RE: Planning Application. Variation of Condition 3. Reference Number: 2016/5873/P (As Built revision application for 2014/1387/P).

I am writing to object to the recently submitted planning Application, for the Loft Extension at 94C College Place. Why they have not built what they had permission for is quite beyond comprehension.

PHOTOGRAPH 2

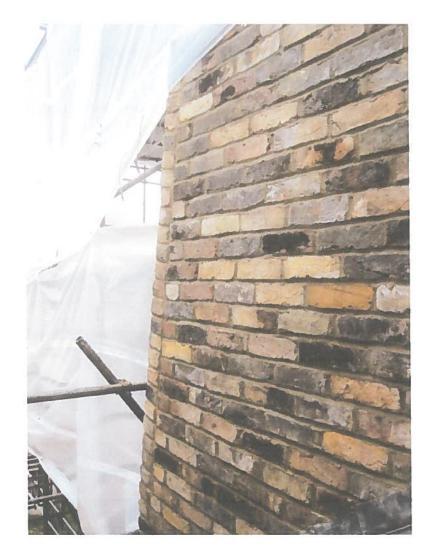
Photograph later the same day 17/09/16.

I have asked the Party Wall Surveyors and Building Control to look at this and will continue to pursue this aspect to seek removal of the illegal wall. There is no permission to have built this at all, nor climb onto the roof of 96 College Place (the adjoining property), breaking slates in the process. (see Photograph 2).
